VILLAGE OF WARWICK PLANNING BOARD MEMORANDUM

To: Chairman Jesse Gallo & Members of the Planning Board
From: Jason A. Pitingaro, PE
Subject: Yesterday's Restaurant, 16 Elm Street, Section 210 Block 12 Lot 14
Date: May 13, 2025

DUMPSTER ENCLOSURE

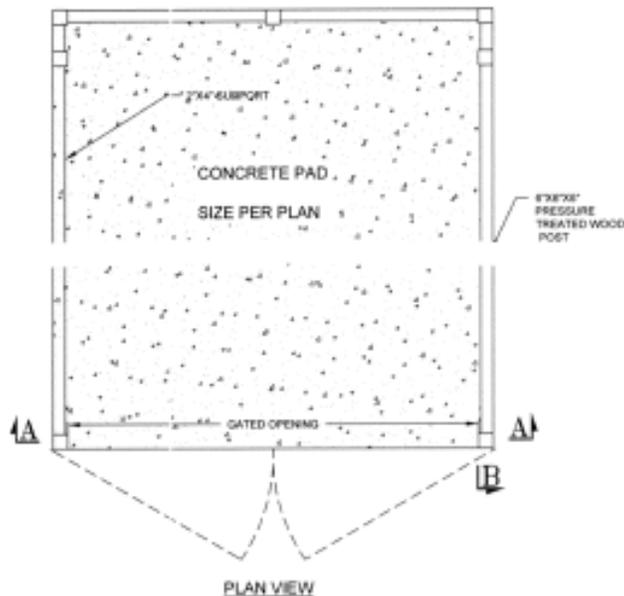
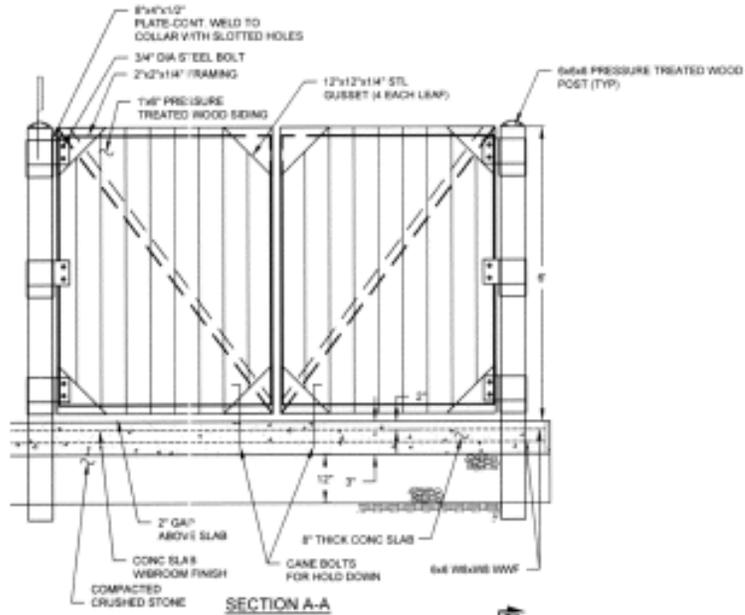
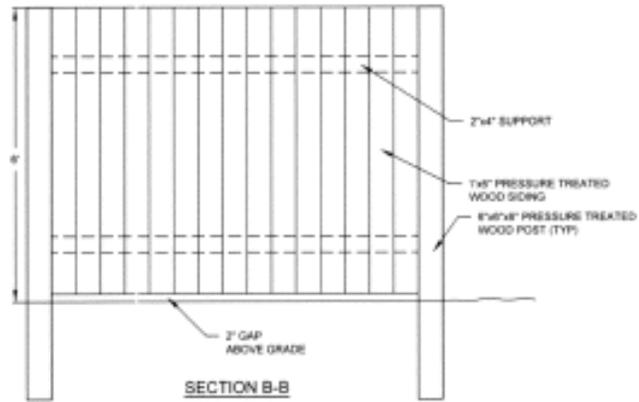
6. The proposed dumpster enclosure and privacy fence do not meet all the specifications of the enclosure and fence details on the previously approved site plans. A gate had previously been

provided for the dumpster enclosure. The Planning Board shall review the enclosure details. (See attachment annexed to this memorandum.)
